SUMMARY OF B440 CLOSEOUT REPORT RESPONSE TO COMMENTS TO CDPHE

- 3) Section II, Utility Disconnect –
 - a) Please expand this discussion to properly identify the isolation performed at the “two manholes”. Also, the figure provided in Appendix 1 states that the sanitary sewer was plugged at manholes 46 and 47, and also states that the “Grease Trap” SW of B440 was removed. Since this trap appears to be attached to the sanitary sewer system, plugged at MH 46, this should be included in the discussion. In addition, please provide a discussion regarding the disposition of the storm drains associated with B440 (including the ones between the Eastside and the Westside, and running east west immediately south of B440).
 - b) Beryllium – Please modify this discussion to properly state that Be sampling was conducted in both the East and West sides of B440, as provided in Appendix 3.

ATTACHMENT 2 - B440 FOUNDATION REMOVAL

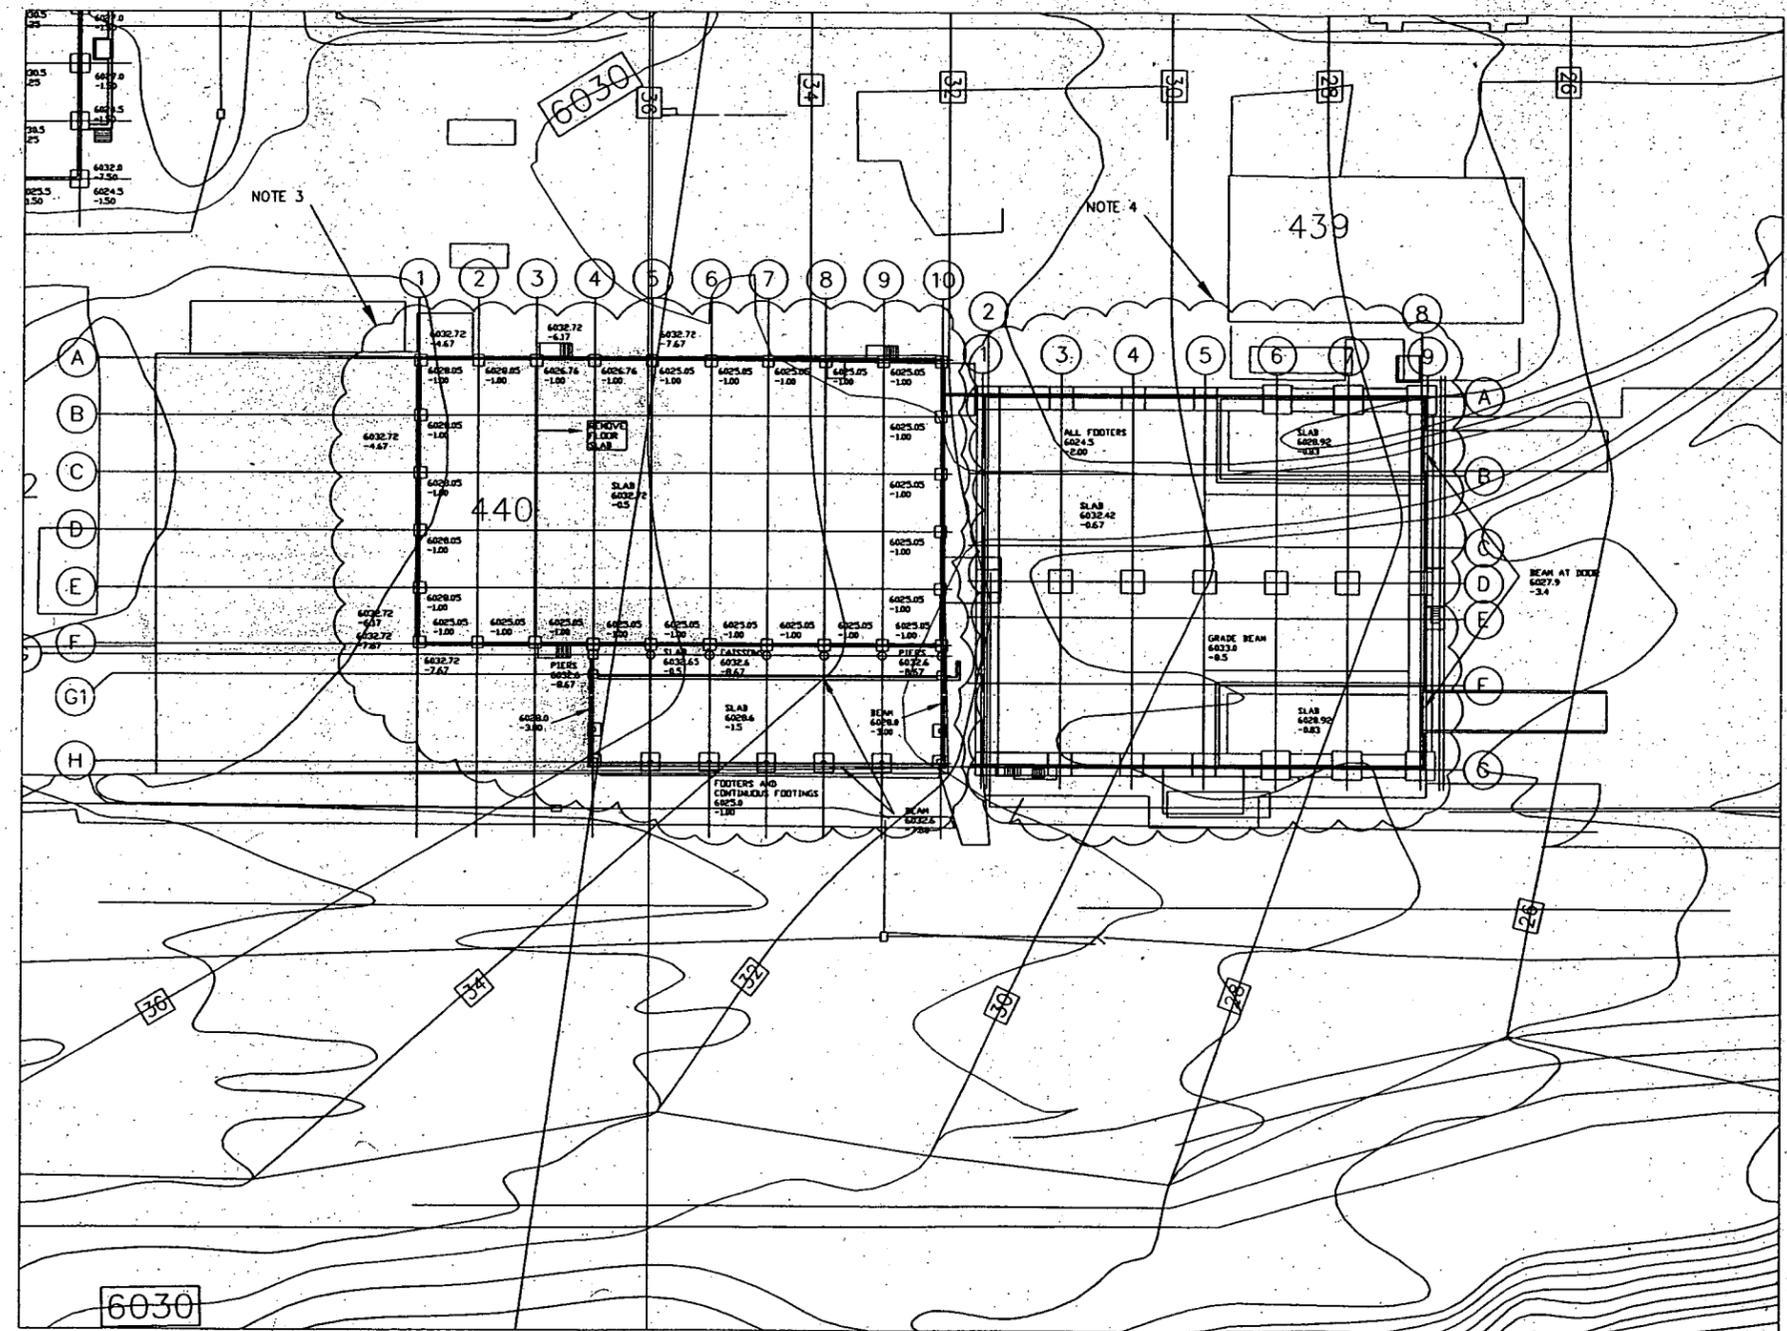
- 5) Appendix 1, Article 2 –
 - a) Please provide a figure that shows the locations of the rooms and columns discussed in this report and on the figure.
 - b) It would also help if the figures provided (Appendix 1, articles 1 & 2) were properly identified. Currently neither of the figures is properly identified as article 1 or 2.
 - c) Please show the removed section of the slab removed because of the contamination, and the portion of the slab removed to expose and remove the railroad tracks.

- a) New figure Article 3 is attached that shows locations of rooms along with Article 2 showing columns.
- b) Articles 1/2 have been labeled in the attached PDF file.
- c) Article 2 has been updated to reflect that all concrete surrounding the railroad tracks was removed, no contamination was found during the demolition around the rails.
- 6) Appendix 2 – Why are only some Contact Records provided rather than a complete document record for B440? Should provide all records for B440, to include all CRs, RLCR, PDSR, Notifications, etc.

Structures Remaining and Removed for Building 440

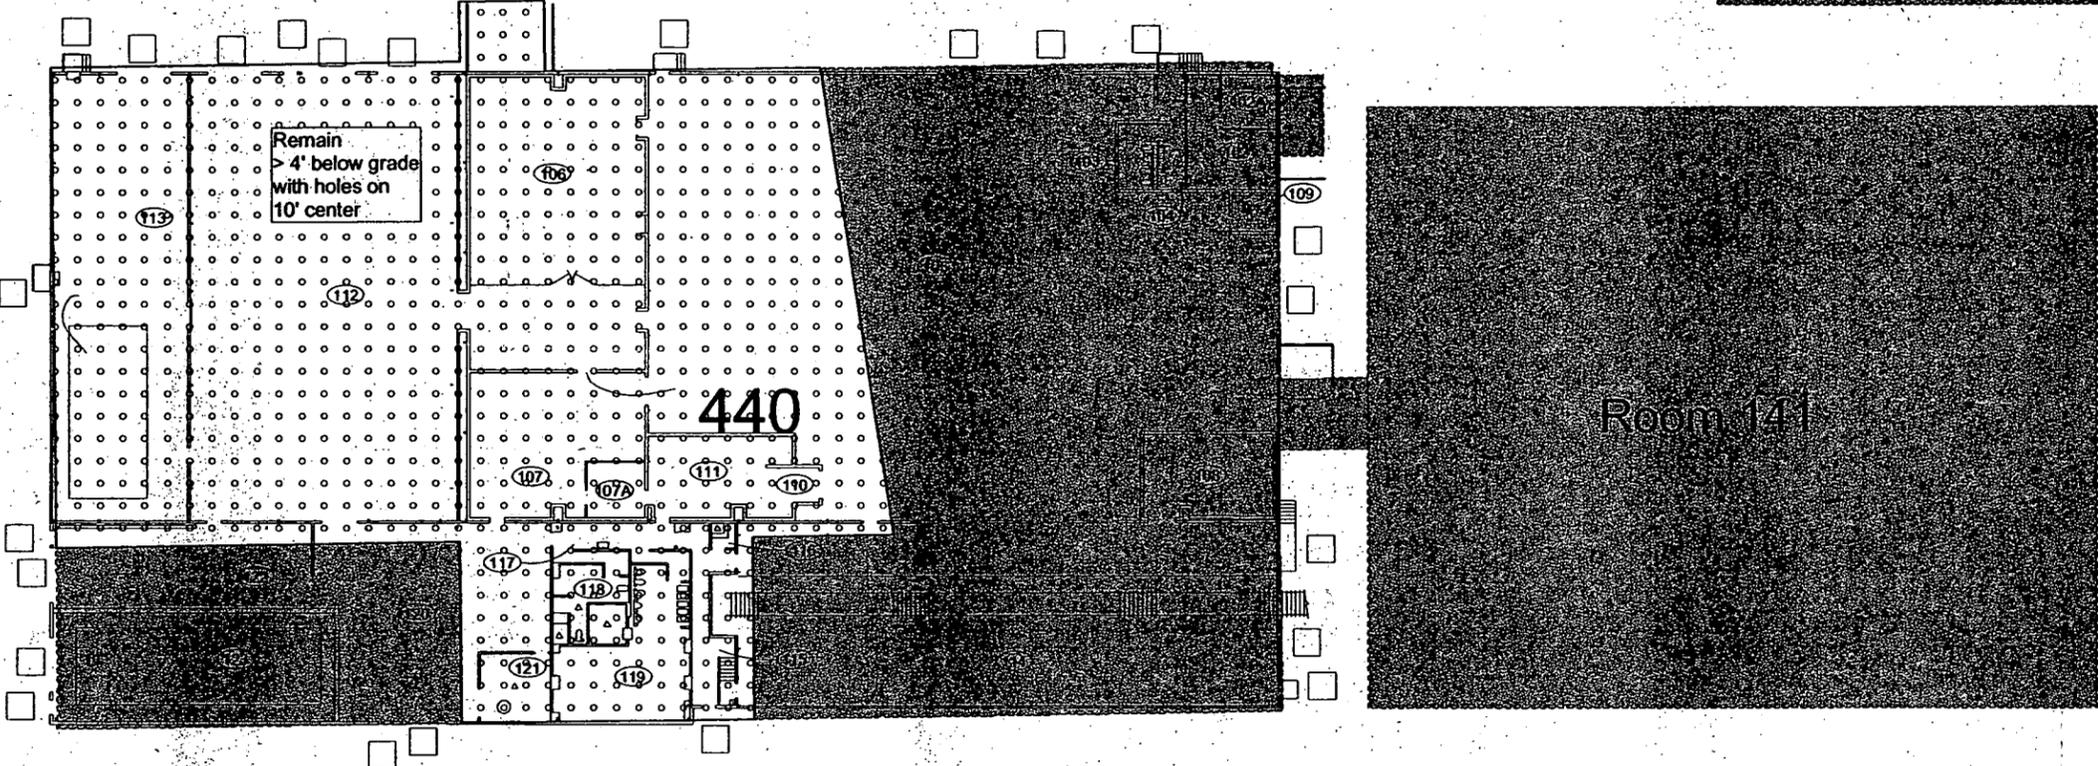
- 4) Section IX - Please expand this discussion to properly address the condition of all remaining infrastructure, including the condition of the slab and the removed section for the railroad tracks and contamination, as well as the associated concrete and asphalt.

Revise Section IX as follows: Figure Attachment ## depicts the amount of slab removed and that which remains greater than four feet below grade. The portions that remain had holes punched in them on 10' centers for groundwater considerations. All of the slab surrounding the railroad tracks was removed and surveyed for release as sanitary waste. No other infrastructure remains at the B440 site.
